Safety Inspection Report

Alden Theatre
Worcester Polytechnic Institute
100 Institute Road
Worcester, MA 01609

Requested By: Kyle Hobin
Inspection Date: October 2, 2009
Inspector: Bill Sapsis

Photo 04.jpg

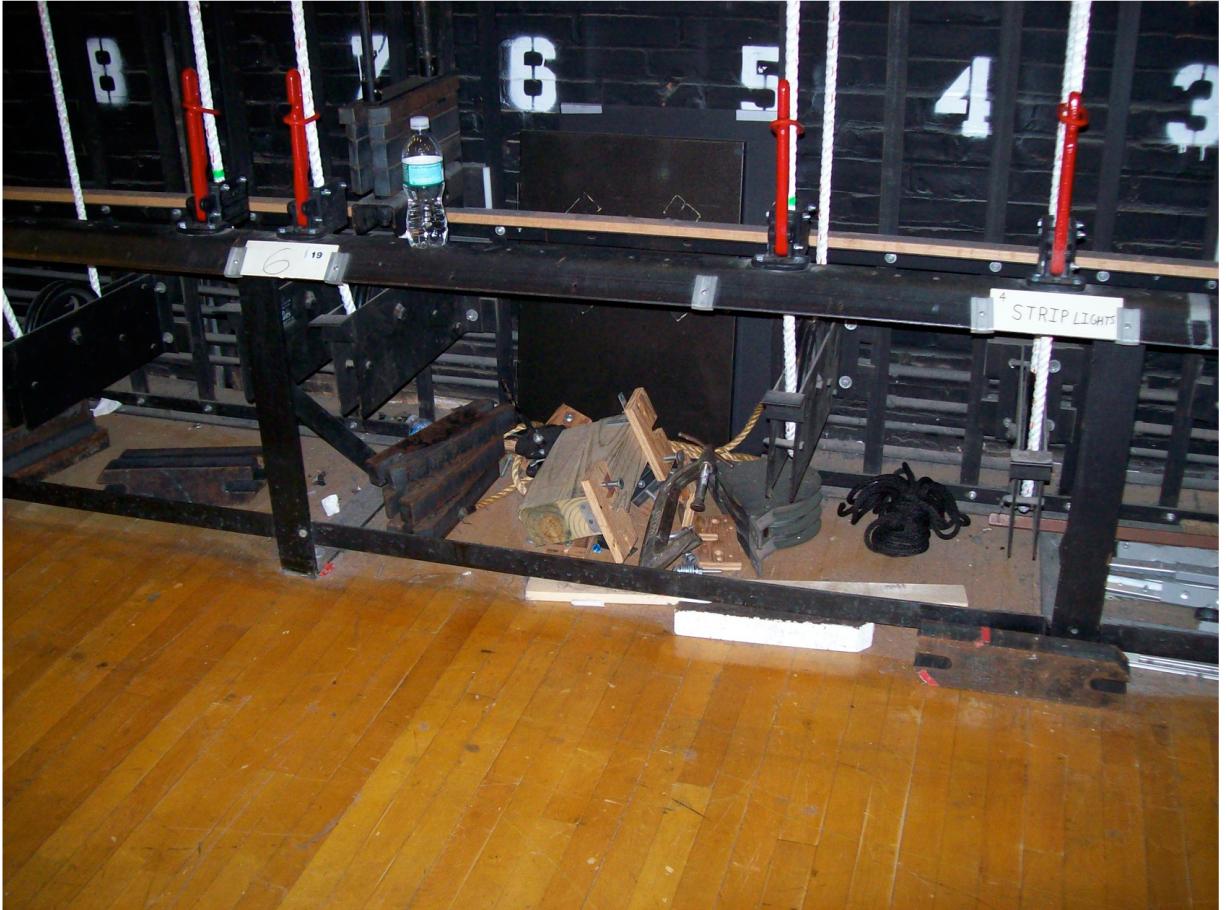
2.8. A railing is needed on the stage left side of the grid. **Photo 4**

Photo 06.jpg

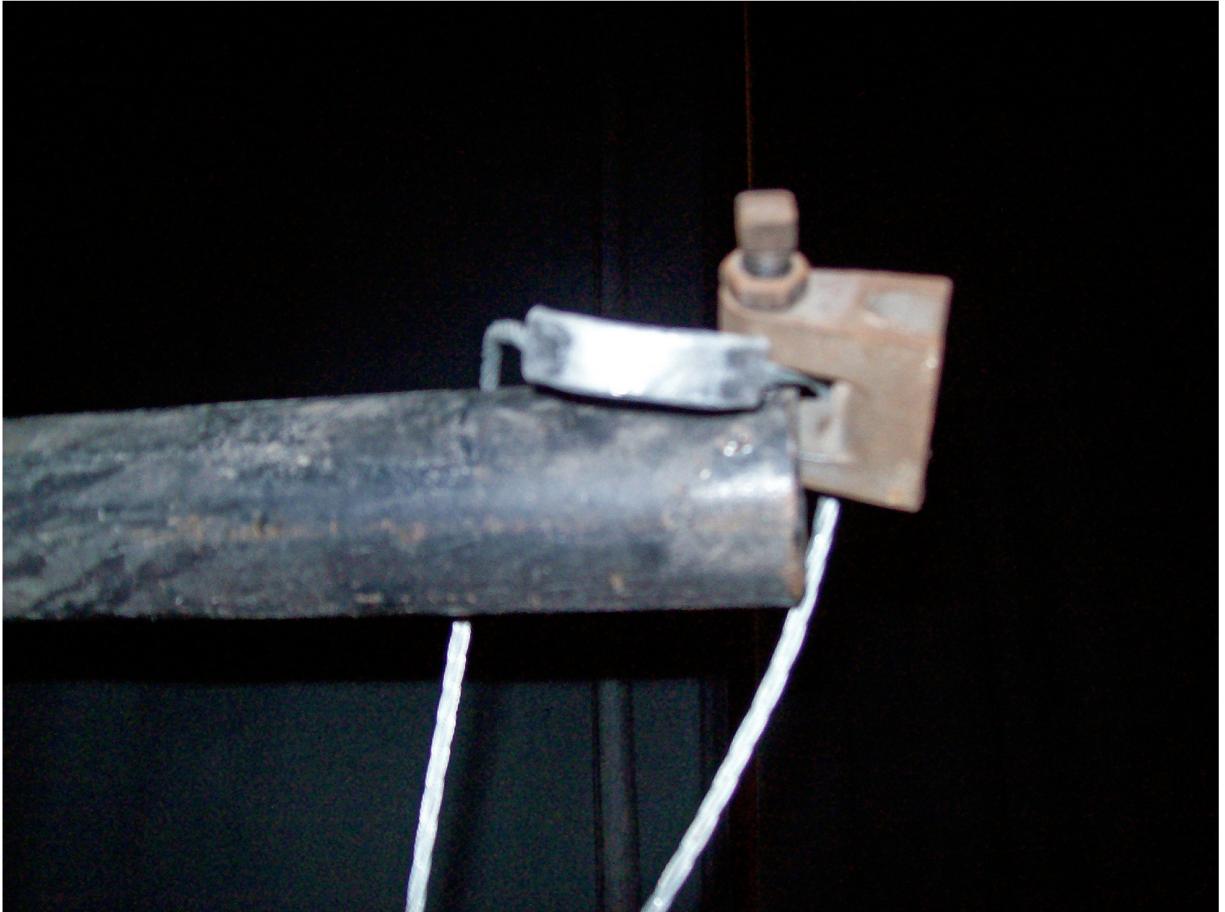
- 4.7. The connector strip junction box on the # 3 electric has a loose cover. It is held on by only one screw. **Photo 6**
- 4.8. Cast iron C-clamps are used to support the power feed cables for the strip lights at the ends of their respective battens. These clamps are not rated for this application and should be replaced with rated clamps. **Photo 7**

Photo 09.jpg

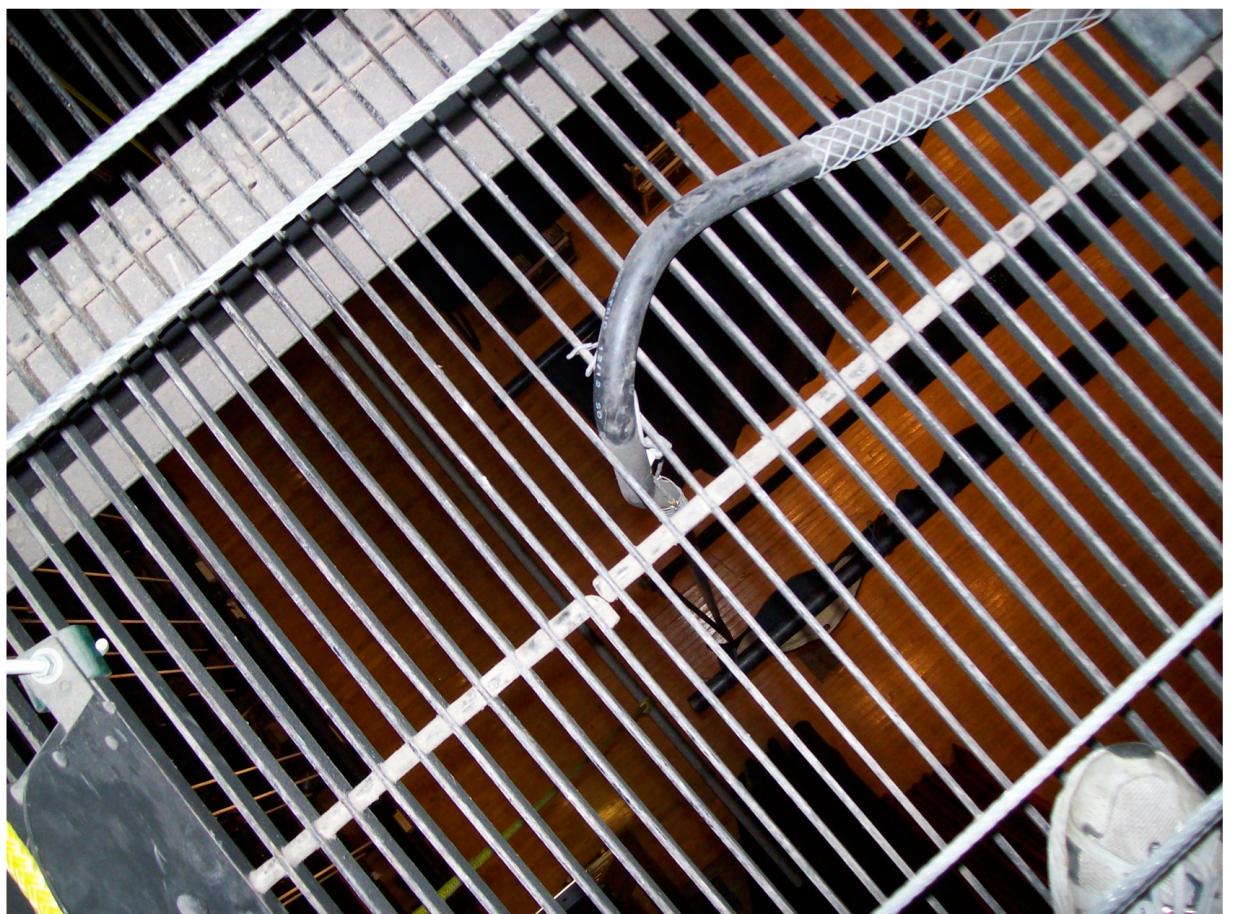
- 4.11. Several of the dead hang chains are wrapped around the subway grating. The grating was not designed to carry a concentrated load. A bracket that spreads the weight over a wider area would be more appropriate for this application. **Photo 9**
